RS-21-015

Byron Station, Units 1 and 2
Renewed Facility Operating License Nos. NPF-37 and NPF-66
NRC Docket Nos. 50-454 and 50-455

Braidwood Station, Units 1 and 2
Renewed Facility Operating License No. NPF-72 and NPF - 77
NRC Docket Nos. STN 50-456 and STN 50-457

Subject: Response to Request for Additional Information Related to Relief Request for Braidwood I4R-11 and Byron I4R-18

Figure 1 - Byron Unit 1 Hoop Tendon Force Trend & LCL / 1 - 30 Year Surveillance Results

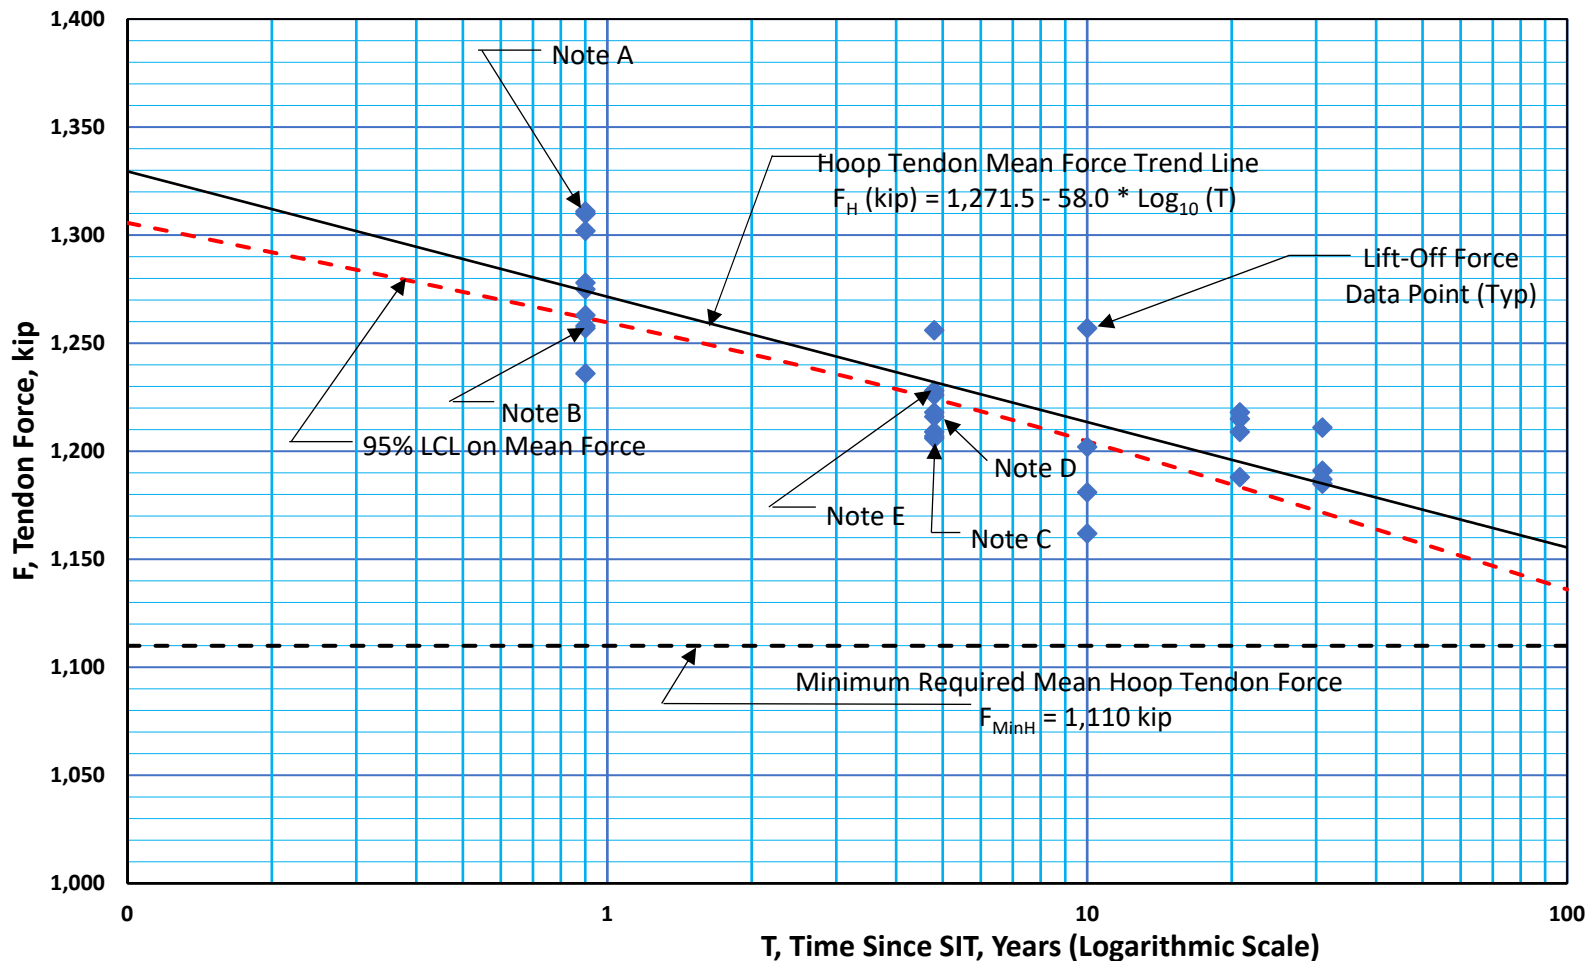
5. There are ten numerical values listed in Table 3 for Unit 1 year 1 hoop tendon forces, but only seven forces are plotted in figure 1. There are 8 numerical values listed in Table 3 for Unit 1 year 5 for hoop tendon forces, but only four are plotted in figure 1. Provide an explanation for the discrepancy.

Figure 1 - Byron Unit 1 Hoop Tendon Force Trend & LCL / 1 - 30 Year Surveillance Results indicate that the prestressing force is decreased from year 1 to year 5 and decreased more to year 10, but then is reversed to increase from year 10 to year 29 and is decreased again to year 30.

(b) With respect to sub-question 5, all points on Table 3 for Unit 1 year 1 hoop tendon forces and Unit 1 year 5 for hoop tendon forces are plotted in Figure 1.

Since the data points were close in values, as a result, they were superimposed on each other such that they cannot be distinguished on the plots. Specifically, three of the lift-off forces measured during the 1st year examination, as listed on Part D (Byron) Table 3, are 1,310, 1,310 and 1,311 kips and have a spread of only 1 kip. The three symbols plotted for these are effectively superimposed and cannot be distinguished from one another on the plot (Figure 1). Two of the measured forces are 1,257 and 1,258 kips and have a spread of 1 kip. Again, the symbols for these are effectively superimposed and cannot be distinguished from one another on the plot (Figure 1).

Three of the forces measured during the 5th year are 1,206, 1,207 and 1,209 kips and have a spread of 3 kips. The three symbols are partially superimposed but close inspection shows that these do overlap. The same is true for the closely spaced values of 1,216 and 1,218 kips (2 kip spread) as well as the closely spaced values of 1,226 and 1,228 kip (also a 2 kip spread).

It is to be noted that the trend line and LCL computations use all of the data listed in Table 3. Notes provided in Figure 1 provided in this letter describes the plotted numerical values listed in Table 3 for Unit 1 year 1 and 5 for hoop tendon forces. Therefore, there is no discrepancy between the numerical values listed in Table 3 and Figure 1.

- Note A - Overlapping / superimposed symbols represent 3 plotted forces; 1,310, 1,310 & 1,311 kips as listed in Table 3
- Note B - Overlapping symbols represent 2 plotted forces; 1,257 & 1,258 kips as listed in Table 3
- Note C - Overlapping symbols represent 3 plotted forces; 1,206, 1,207 & 1,209 kips as listed in Table 3
- Note D - Overlapping symbols represent 2 plotted forces; 1,216 & 1,218 kips as listed in Table 3
- Note E - Overlapping symbols represent 2 plotted forces; 1,226 & 1,228 kips as listed in Table 3
